# Access Compliance Report

## Public Rights-of-Way

### (Curb Ramps)

Intersection ID: 10016404	Main Street: MILHAVEN_LN	Cross Street: N/A	Location: E
ADA ID: BCB676711422	Ramp Type: Perp	Initial Pass/Fail: Fail	Overall Compliance: No
		Severity Score: 12.5

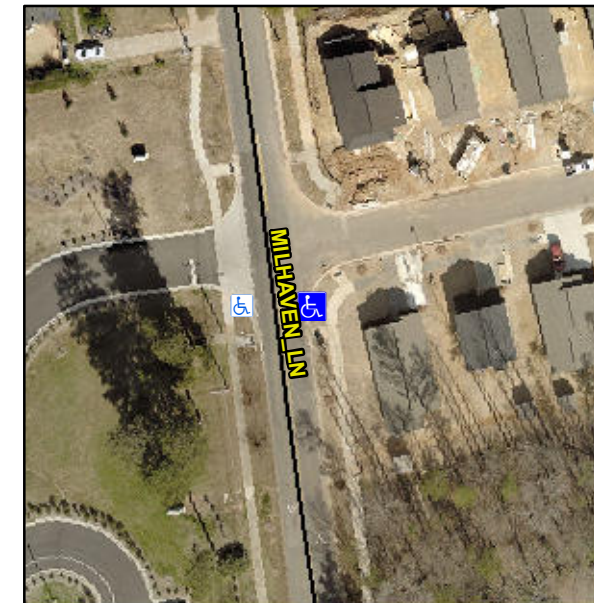
**Remove & Replace Entire Ramp.**

**Not Found, R304.2.2**

Compliance	Description	Data	Compliance	Description	Data
N/A	Ramp Length (in)	60.0	No	Ramp Slope (%)	10.1
Yes	Ramp Width (in)	57.5	Yes	Ramp XSlope (%)	0.9
N/A	Flare Type LT	N/A	N/A	Flare Type RT	N/A
N/A	Flare Slope LT (%)	N/A	N/A	Flare Slope RT (%)	N/A
N/A	Flare Traversable LT?	N/A	N/A	Flare Traversable RT?	N/A
N/A	Landing Length (in)	N/A	N/A	DWS Provided?	N/A
N/A	Landing Width (in)	N/A	N/A	DWS Contrast?	N/A
N/A	Landing Slope (%)	N/A	N/A	DWS Length (in)	N/A
N/A	Landing X Slope (%)	N/A	N/A	DWS Full Width?	N/A
N/A	Landing Curb? (Y/N)	N/A	N/A	DWS Offset (in)	N/A
N/A	Shared Landing?	N/A			
N/A	Gutter Ponding?	Yes	N/A	Gutter Slope (%)	N/A
N/A	Gutter Lip Ht (in)	N/A	N/A	Gutter X Slope (%)	N/A
N/A	Painted X Walk1?	No	N/A	Painted X Walk2?	N/A
	X Walk 1 Direction	To W		X Walk 2 Direction	N/A
N/A	X Walk 1 Width (in)	N/A	N/A	X Walk 2 Width (in)	N/A
	X Walk 1 Slope (%)	3.5		X Walk 2 Slope (%)	N/A
	X Walk 1 X Slope (%)	0.3		X Walk 2 X Slope (%)	N/A
